Shoreland Permit Application

Vermont, to be deemed complete. Refer to <i>The V</i> Shoreland Development and related instructions to				
A. Parcel Information 1. Landowner's Name: Shane & Trina Beattie				
2a. Physical Address (911 Address): McLaughlin Rd	1

Subject: RE: Shoreland Permit Application #261, Beattie

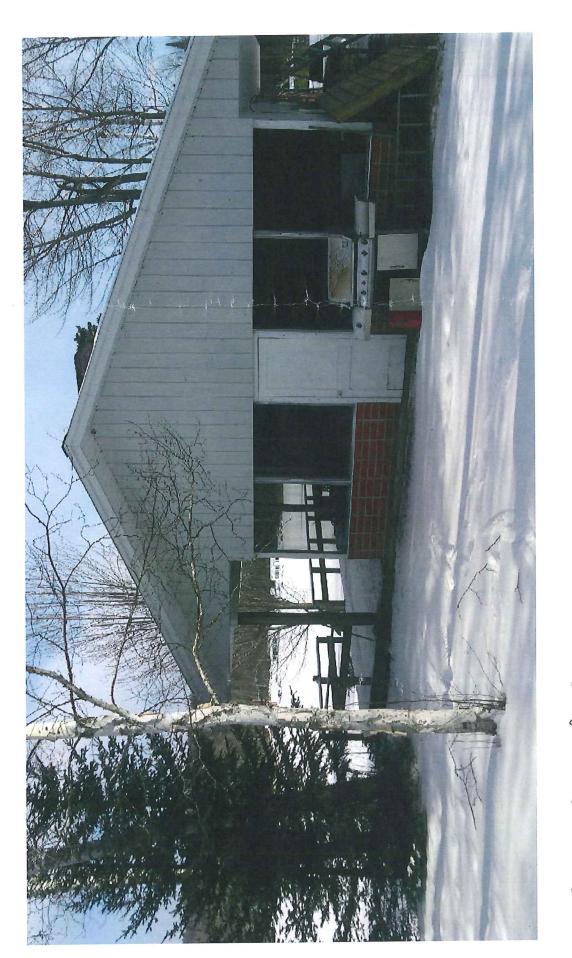
What is the distance from the mean water level to each group of existing trees to be removed?

- 1) Design of pervious patio must be shown to meet criteria:
- a) Gaps (e.g. 4") between decking boards or patio surface (flagstone, brick, pavers, etc.) allow passage of stormwater to the underlying substrate.
 - b) Underlying substrate is not an impervious surface such as concrete, asphalt, compacted dirt/gravel, or compacted crushed stone and allows for infiltration of stormwater (e.g., loose stone bed or vegetation).
 - c) Perimeter of deck or patio is managed for water infiltration (e.g., loose stone infiltration trench or vegetation).
 - d) The deck or patio is of an open design (i.e., the deck or patio does not have a roof).
- 2) More descriptive site plan including all dimensions, locations of vegetation to be removed, and distances from mean water level (including 100' lakeside zone).
- 3) Will the tree stumps remain in place?

Hi Mark the distance for the first group is 65 ft the other group is 95 and 100 ft let me know if you need more info thanks Shane

- 1). a. There is no decking material. The patio will be 30 X25 and will be constructed of pervious brick pavers with recommended gaps between them.
 - b.There will be no concrete or asphalt under the surface, it will be loose sand and crushed stone.
 - c. The deck perimeter will be crushed stone and vegetation only.
- d. The patio will not have a roof, the only roof will be a section over the bar-b-que section in the far corner next to the camp.
- 2). Please see attached advised plan. All area concerning the patio is currently clear of any vegetation except for grass. So if I understand this correctly, no permit is required for that portion of this project? The area next to the camp on the South side, as shown in the pictures is the only area that will be taking any vegetation (cutting 7-8 trees) away in the shoreland protection

3). The tree stumps have to be removed for the construction of the new camp. In our conversation the other day, you asked about re-planting trees, I have no problem with doing so. It is my wife and my plan to plant new shrubs and trees around the patio and camp once the new construction is finished.
